## BOROUGH OF HIGHLANDS LAND USE BOARD REGULAR MEETING

151 Navesink Ave. - Court Room  
Thursday, July 10, 2025 at 7:00 PM

4. LUB25-09: Pahler - 35 Miller St., B54 L13 - Variance
5. LUB24-02: Cahill – Amended Application

## LAND USE BOARD APPLICATION

## DEPRESSED CURB-APRON-SIDEWALK DETAIL

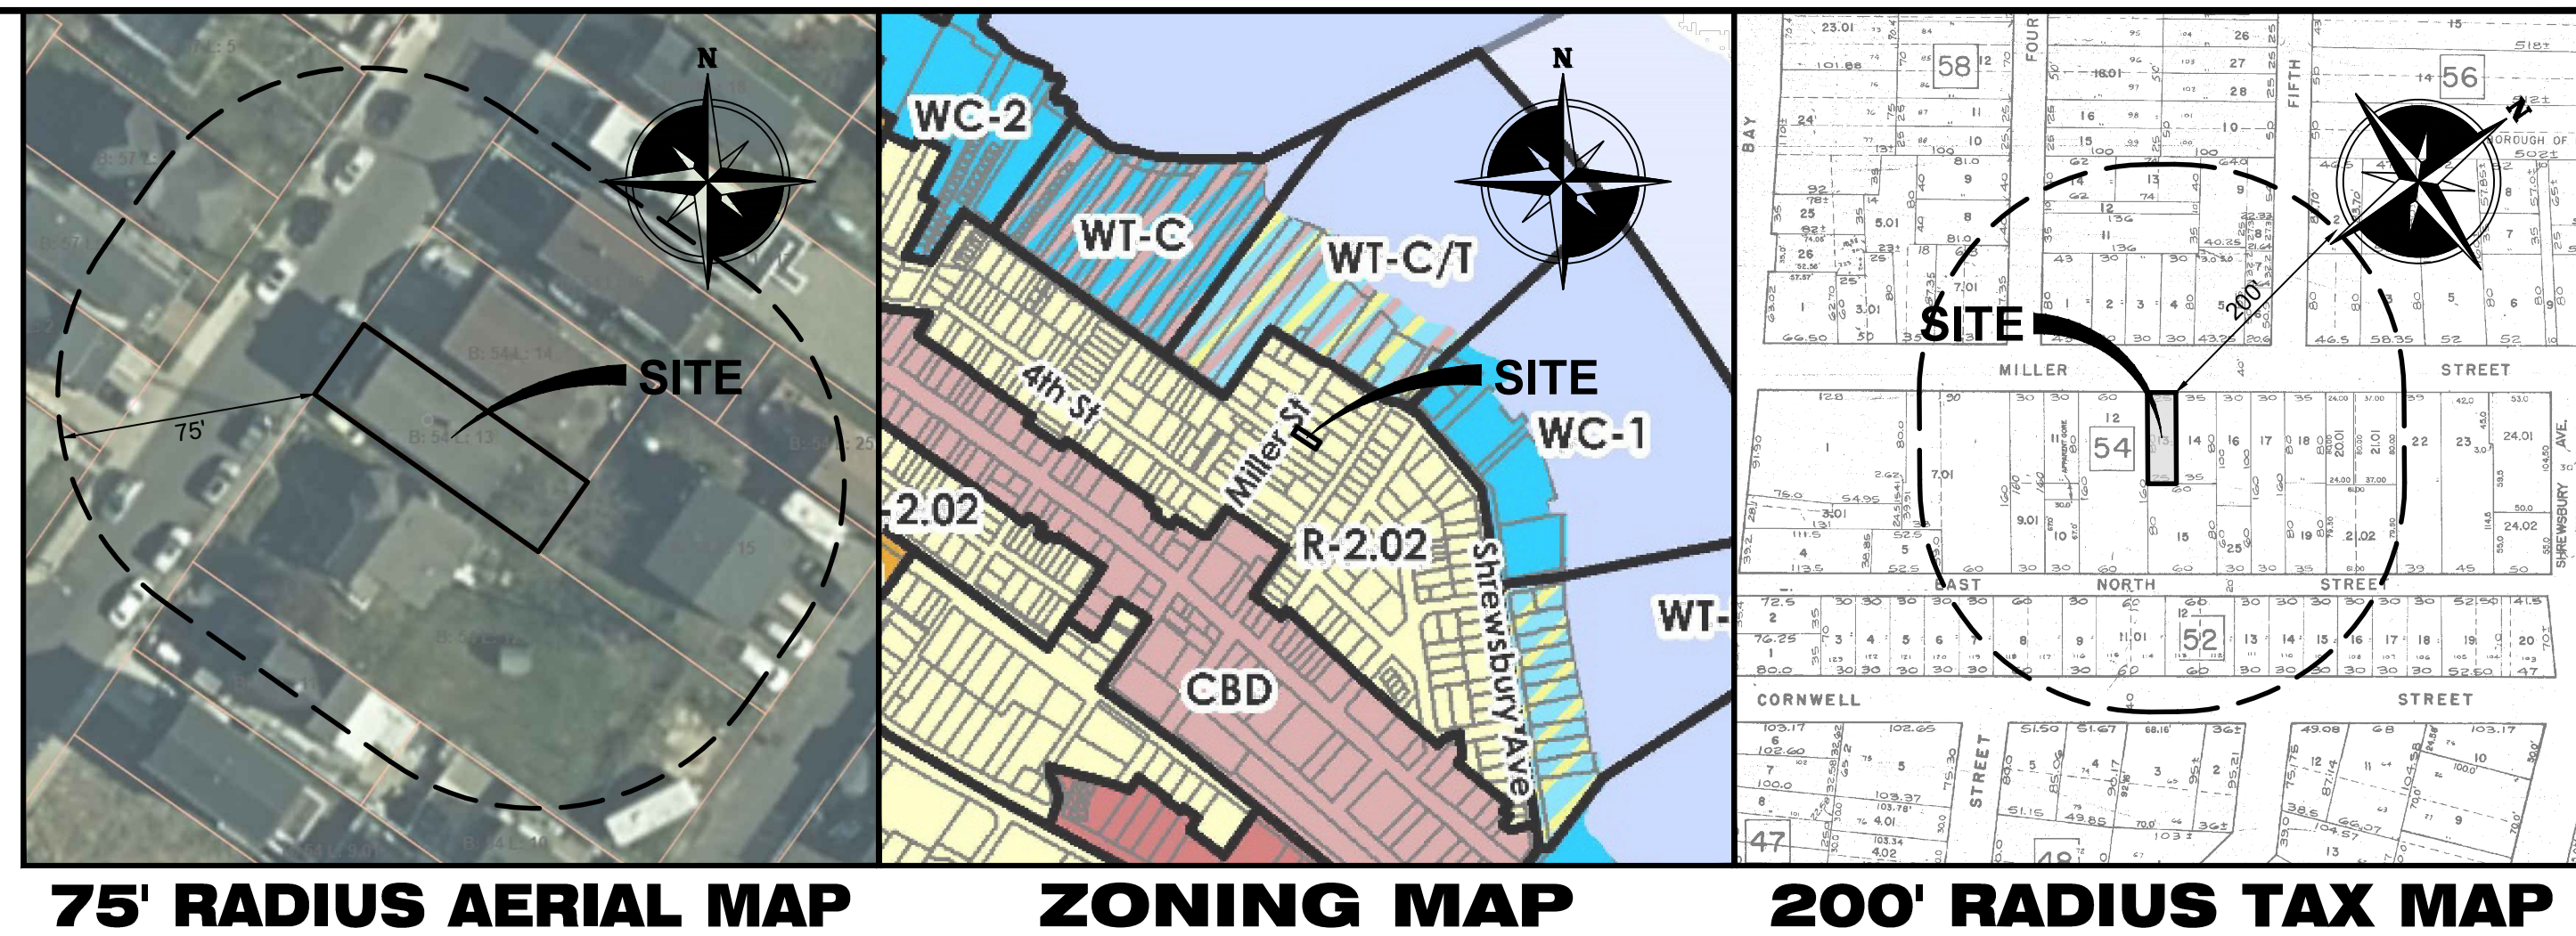
14. Please provide construction details:
  - a. Pavement repair according to § 21-65.15.
  - b. Sidewalk according to § 21-65.17.
  - c. Driveway, apron and depressed curb.

<b>SITE PLAN FOR SINGLE-FAMILY DWELLING W/ BULK VARIANCES</b>	
<b>LOT 13</b>	<b>BLOCK 54</b>
<b>BOROUGH OF HIGHLANDS</b>	
<b>COUNTY OF MONMOUTH</b>	<b>NEW JERSEY</b>
Scale: 1"=10'	Drawn By: DAP
Date: 5/9/25	JOB # E25-00126
VARIANCE	CAD File #
	Sheet # 1 OF 1

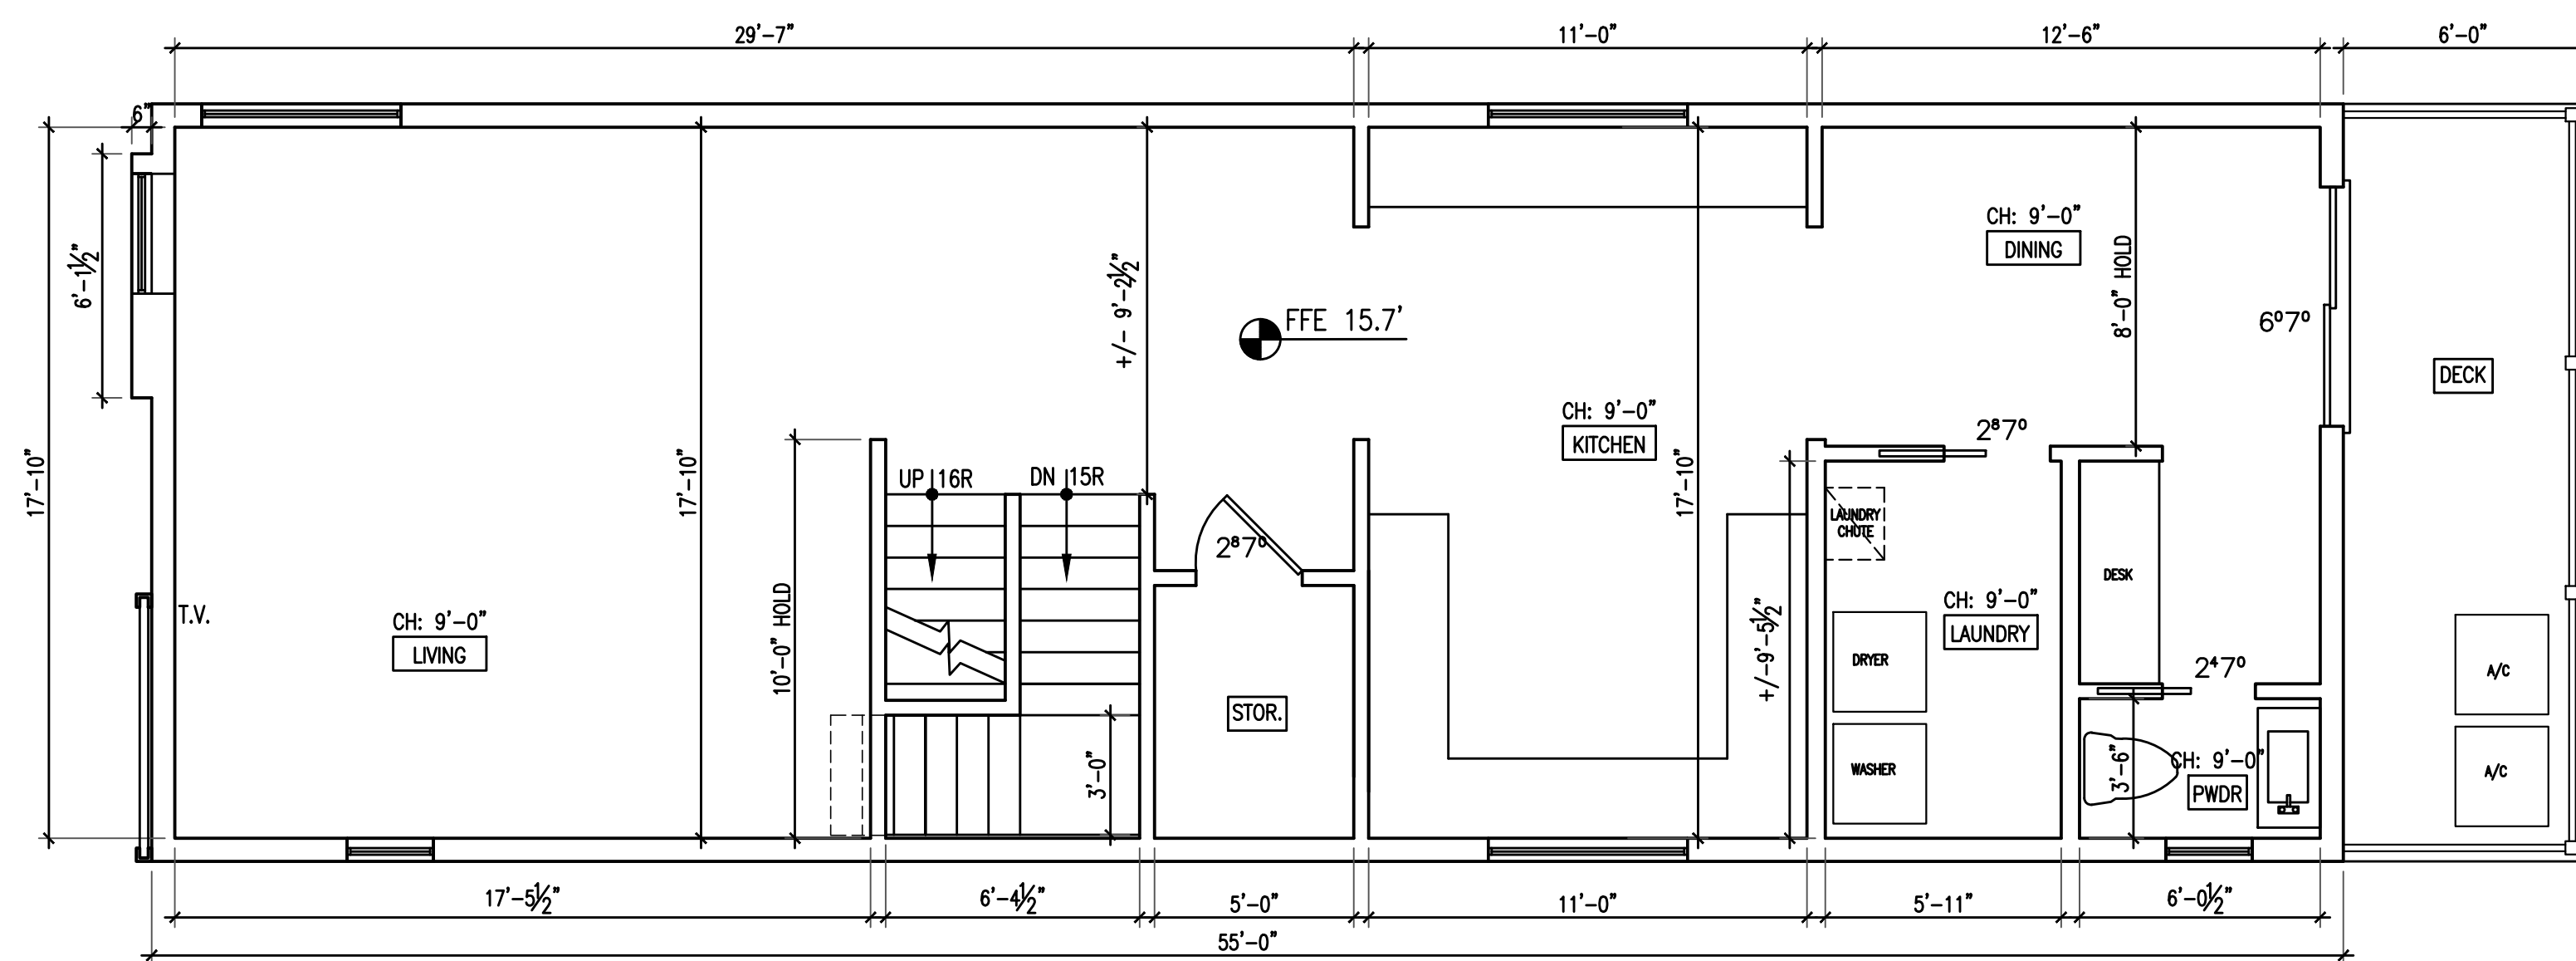
The Applicant has submitted a Variance Plan consisting of zoning information, proposed dwelling, deck, covered porch, driveway, utilities, grading and other site improvements. There are several bulk variances, and there are a number of site improvements that are required to be addressed under Minor Site Plan.

3. The Applicant requires six (6) bulk “c” variances for lot area, lot frontage/width, minimum front setback, side yard setback, rear yard setback, and maximum building coverage. To be entitled to bulk “c” variance relief, the applicant must provide proof to satisfy the positive and negative criteria pursuant to N.J.S.A 40:55D-70c.

1. Please rename the plan to Site Plan.
2. Please provide signed and sealed Architectural plans.
3. The Applicant has submitted an application for a 2 ½ story dwelling, however it appears that the proposed dwelling is more than 2 ½ stories. The attic has an 8-foot ceiling height with family space and a bathroom. The dwelling appears to be three stories. Please provide testimony.
4. Please provide a Certification statement on the engineering plan. Refer to Checklist Item #22.
5. Please provide the location of all structures within seventy-five (75) feet of the property.
6. Please update the minimum lot depth as compliant.

8. Please update the lot coverage table to show covered porches and steps, and concrete, as included items. The total percentage of lot coverage is shown correctly.
9. There is an existing 6 ft wide by 60 ft long easement on Lot 12 along the common line with the property. The easement is described in Deed Book 4538 Page 903 (yr. 1985) as "for the purpose of maintaining, repairing and restoring the dwelling erected upon Lot 13. This easement being necessitated because the side yards on Lot 13 are only six inches on one side and one ft. eleven inches on the other...."

SITE LAYOUT PLAN

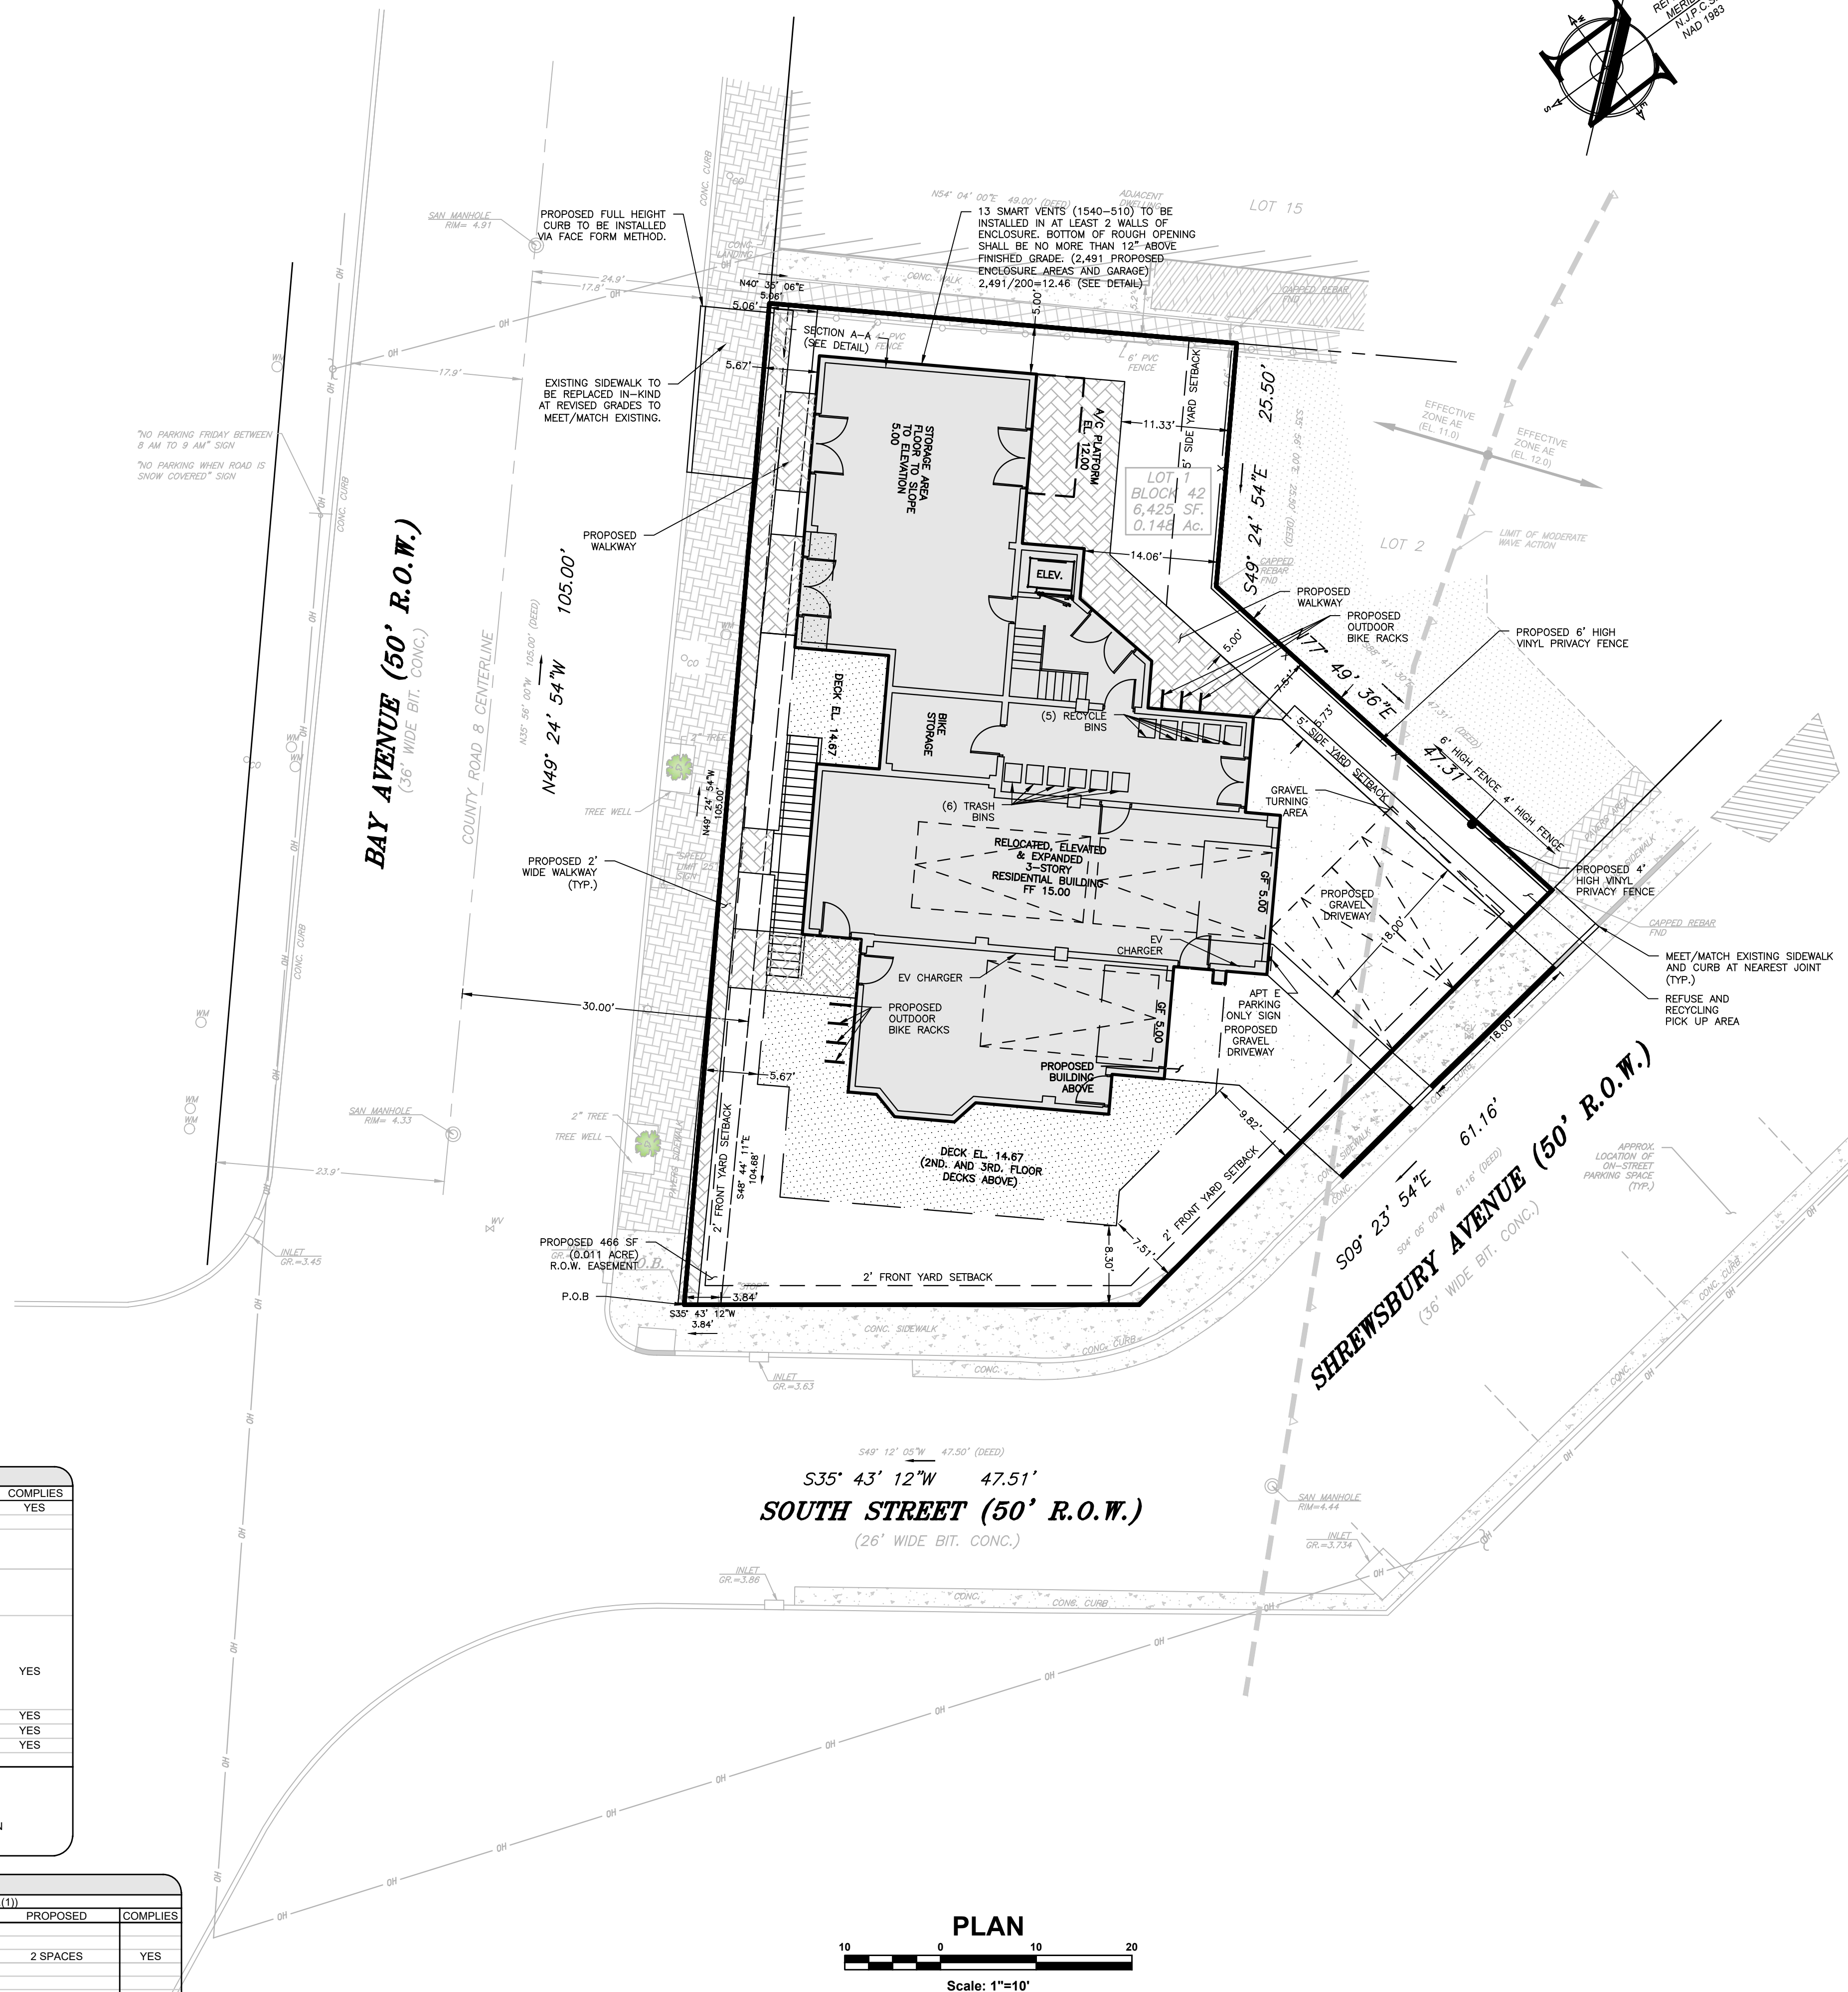
GC5. The Site Layout Plan, sheet C300, has several discrepancies:

- T4. Per Monmouth County Design Regulations § 5.2-3.1C, *driveways on a county road shall be designed so that vehicles are not forced to back out into the County Road.* Additionally, the three driveways fronting C.R. 8, Bay Avenue are not in compliance with MCDR § 5.2-1.2A, On-Site Vehicle Turn Around, *all driveways to the county road on minor subdivisions must be designed with provisions for on-site vehicle turn-around (see figure 2) so that vehicles are not forced to back out into the county road. At a minimum, the driveway must be designed in accordance with the passenger vehicle turning radius templates contained in the current edition of A Policy on Geometric Design of Highways and Streets published by American Association of State Highway and Transportation Officials (AASHTO).* The three driveways fronting C.R. 8, Bay Avenue were not designed with vehicle turnarounds. Revise for compliance with the above stated Monmouth County Design Regulations.
